CONSTRUCTION DOCUMENTS
MAYBERRY, COLORADO - FILING NO. 4
 BEING A REPLAT OF TRACT A, MAYBERRY, COLORADO SPRINGS FILING NO. 3
 LYING THE NORTHEAST QUARTER OF SECTION 14, TOWNSHIP 14 SOUTH, RANGE 63 WEST OF THE 6TH PRINCIPAL MERIDIAN
 COUNTY OF EL PASO (UNINCORPORATED), STATE OF COLORADO

PCD FILE NO. SF2317

MAYBERRY - FILING NO. 4

CONSTRUCTION DOCUMENTS

OVERALL SITE
PLAN

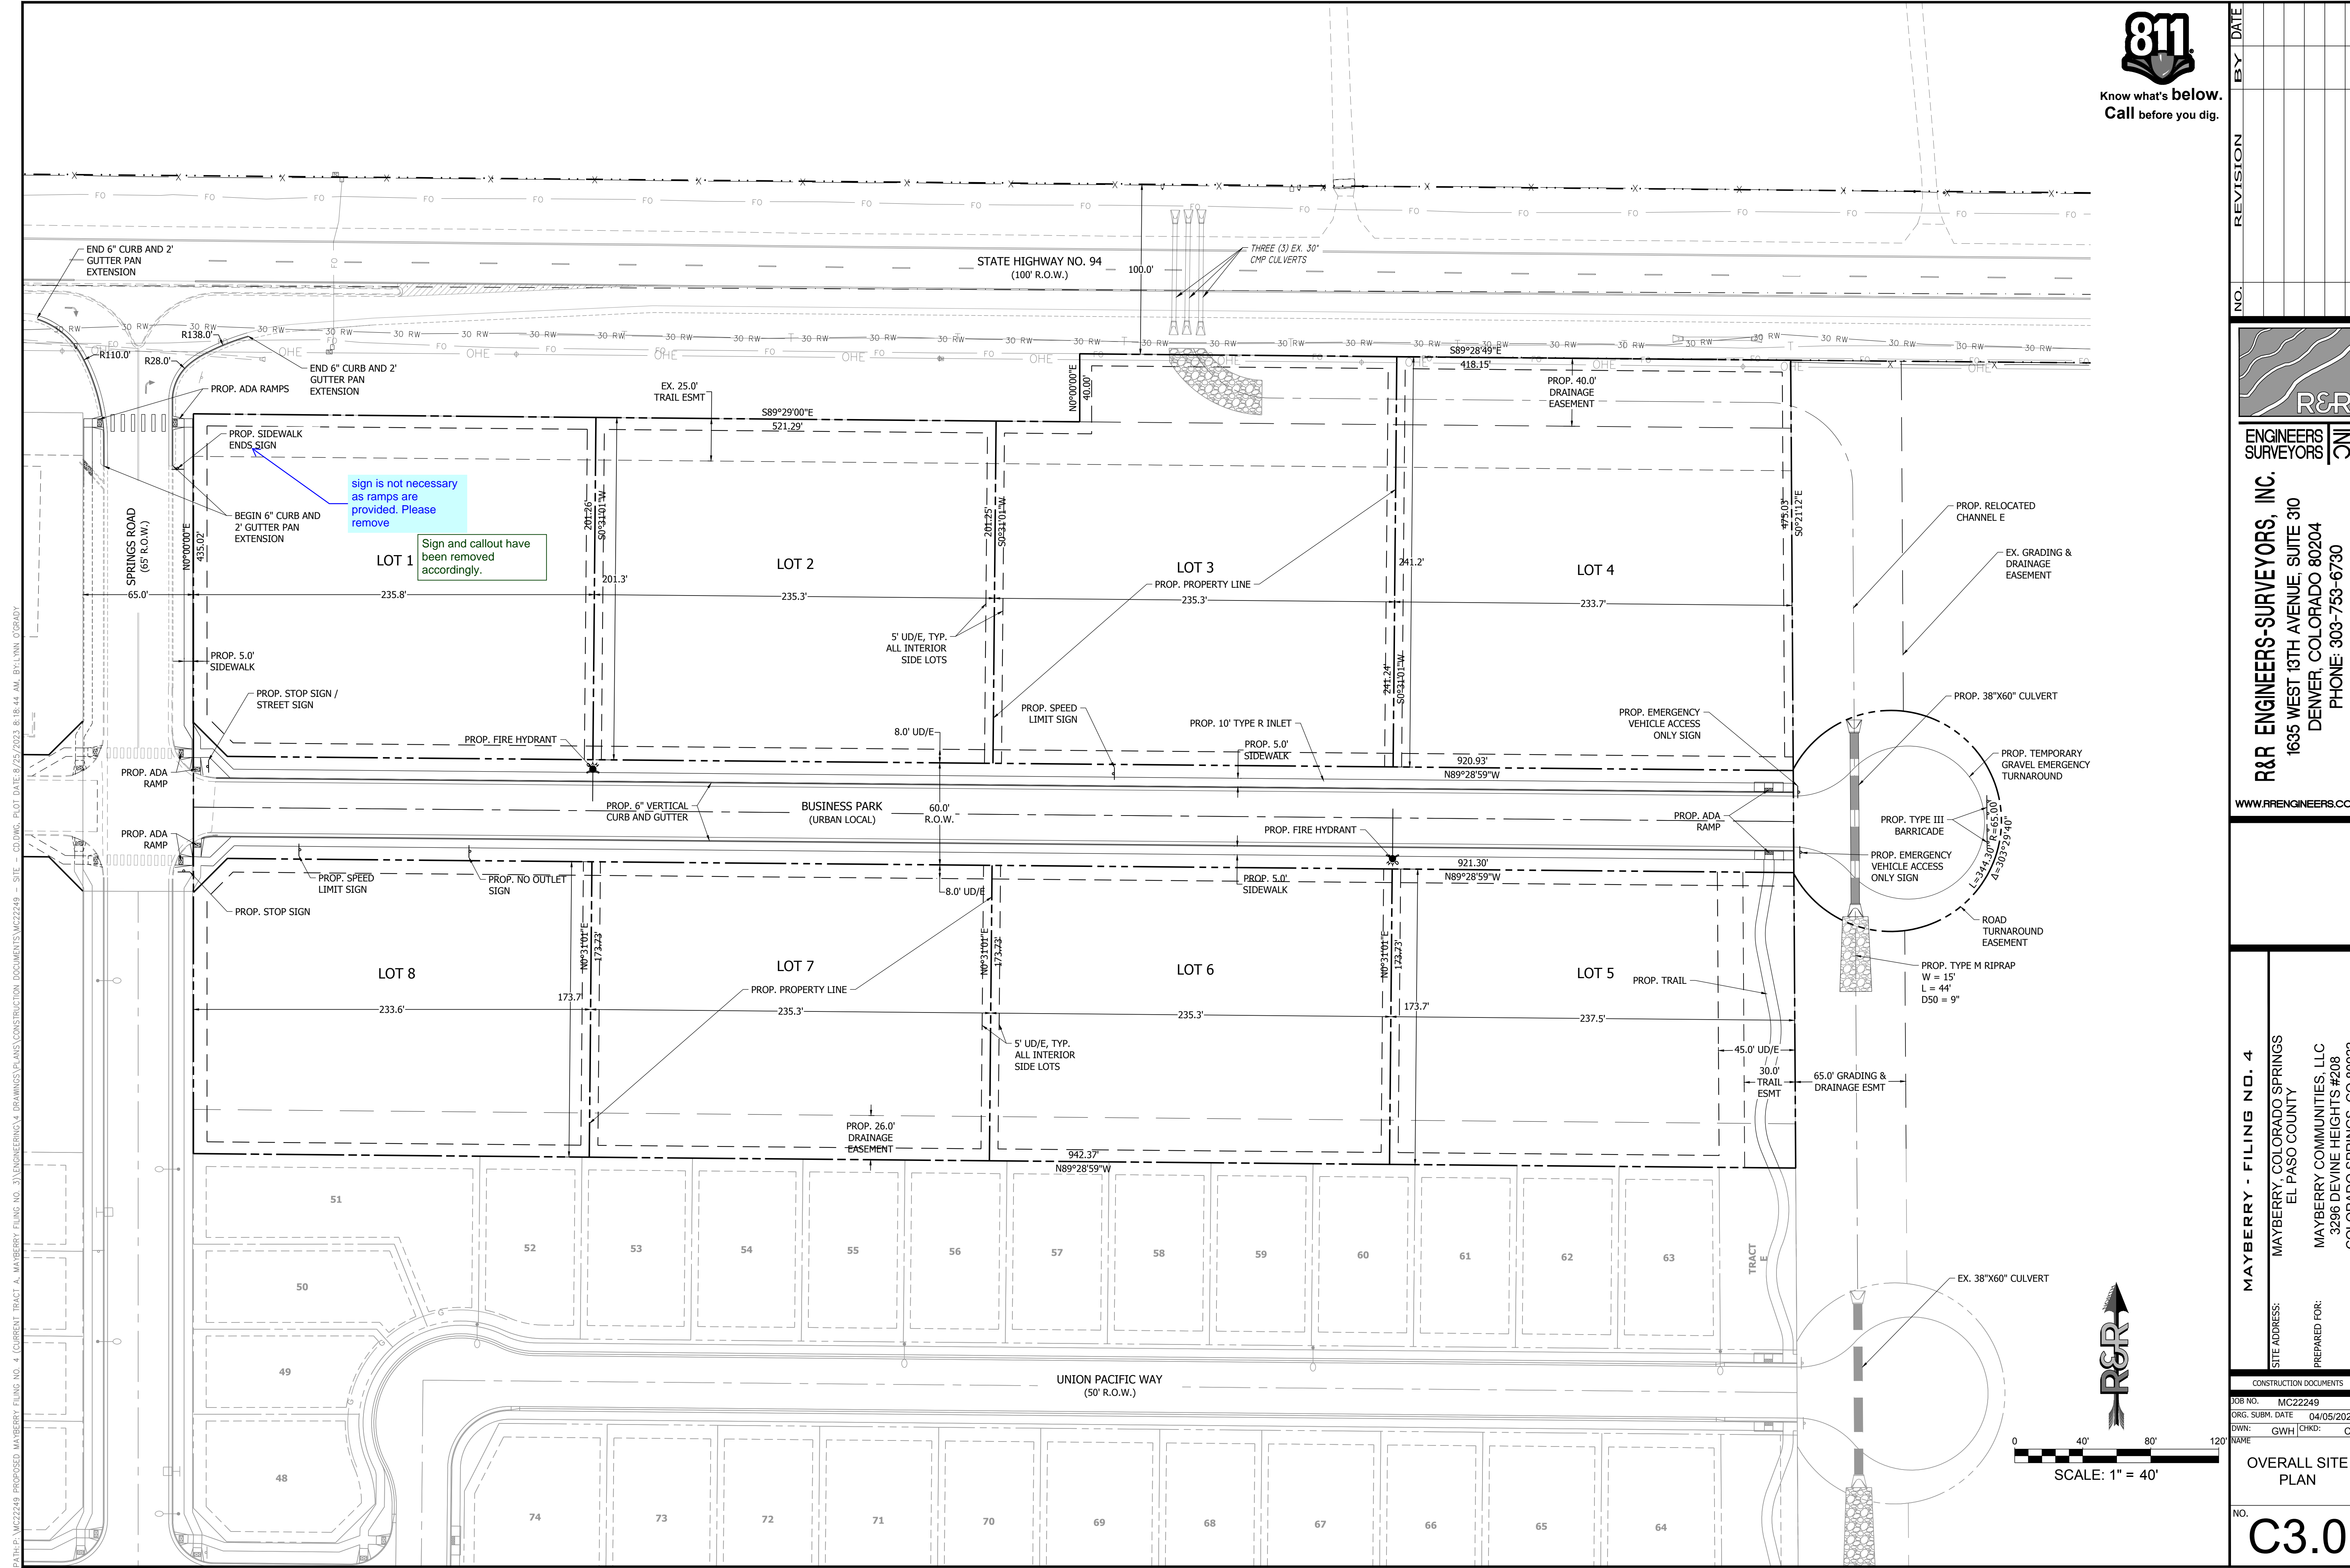
sign is not necessary as ramps are provided.
Please remove

CONSTRUCTION DOCUMENTS
JOB NO. MC22249
ORG. SUBM. DATE 04/05/2023
DWN: GWJ CHKD: CJJ
BUSINESS PARK PLAN & PROFILE - EAST
NO. **C4.1**

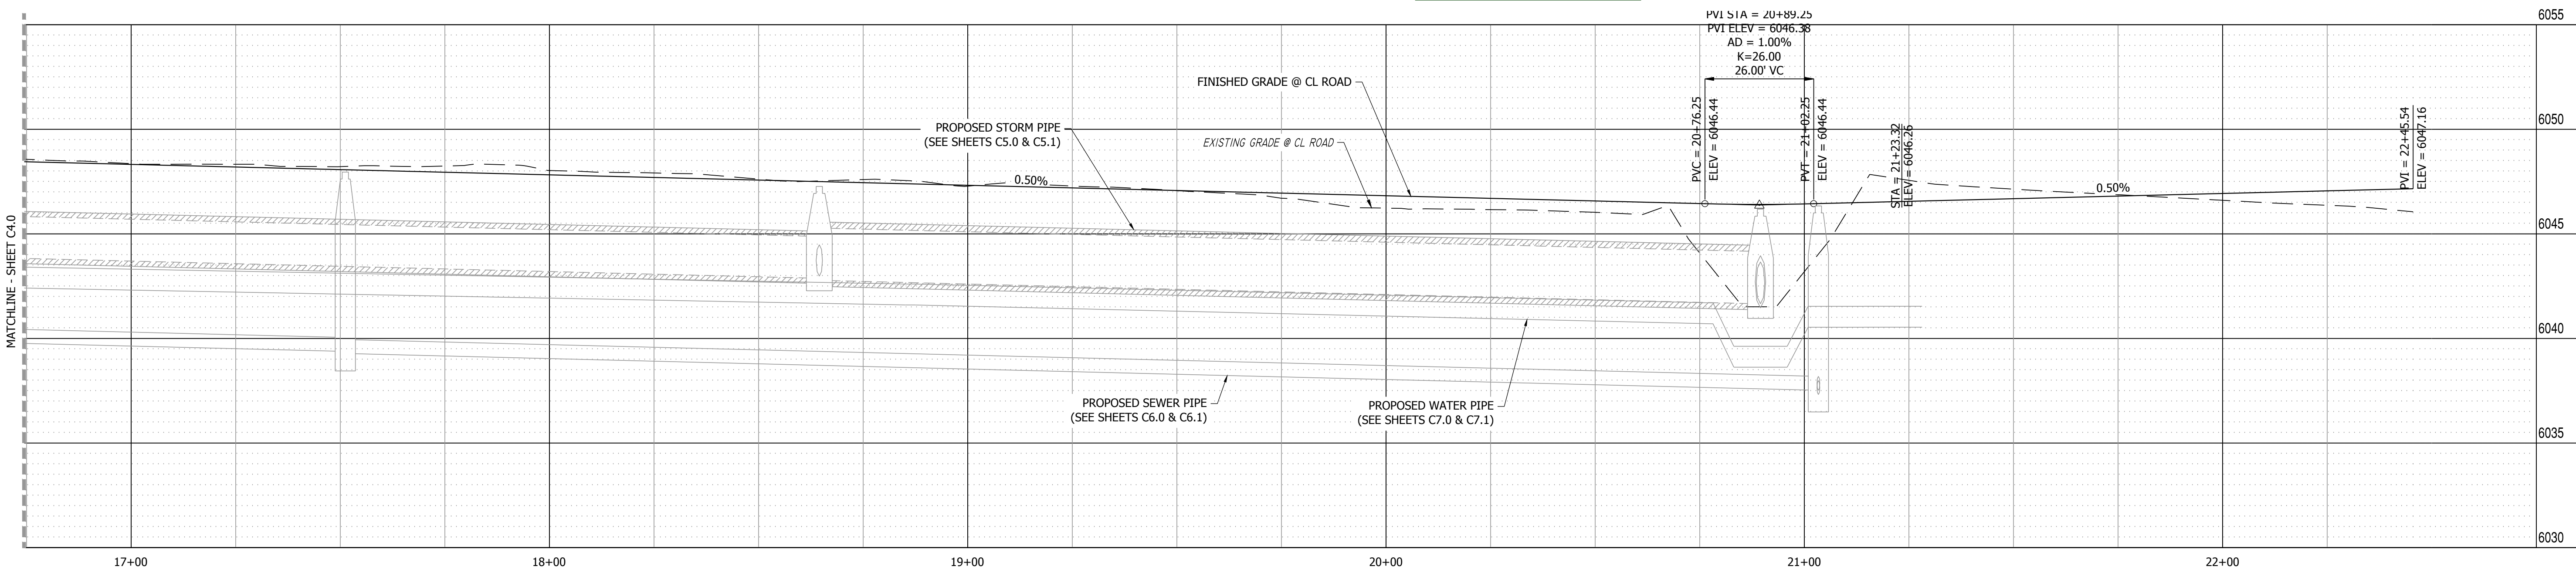
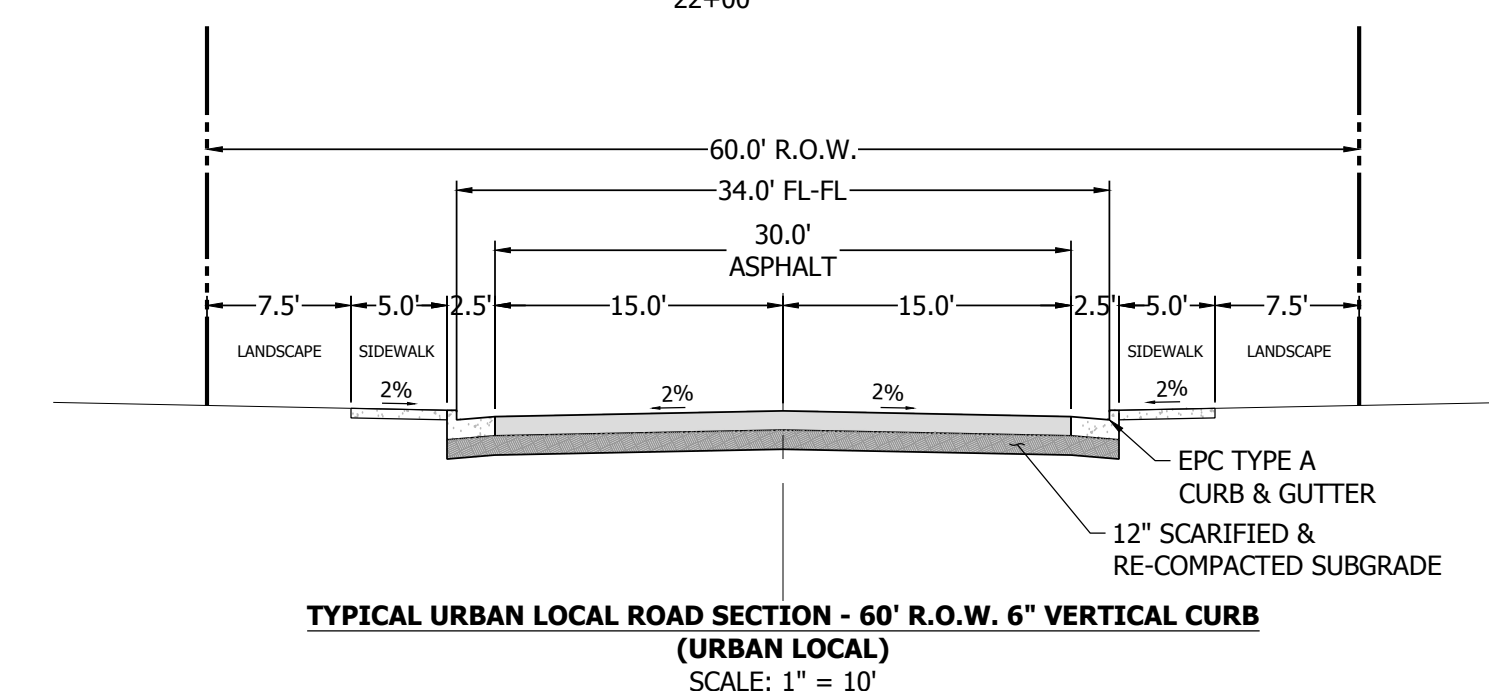
Trail was identified in the PUD plan. Please provide. Contact the planner Ryan H., whether a PUD change is needed if choosing to remove from the plan.
update GEC and FAE accordingly

review comment: Sidewalks should run behind inlets unless an integrated design is provided. ADA requirements apply.
Review 2. Please identify how the inlets will be integrated with the sidewalk. Staff strongly recommends that the sidewalk should run behind the inlets. Staff has encountered many issues meeting ADA requirement when the sidewalk is not run behind.

review 1 comment:
Sidewalks should run behind inlets unless an integrated design is provided. ADA requirements apply.

Trail was identified in the PUD plan. Please provide. Contact the planner Ryan H., whether a PUD change is needed if choosing to remove from the plan.

Per meeting held on 10-11-2023, this comment can be omitted and trail easement will not be provided on Lot 4.
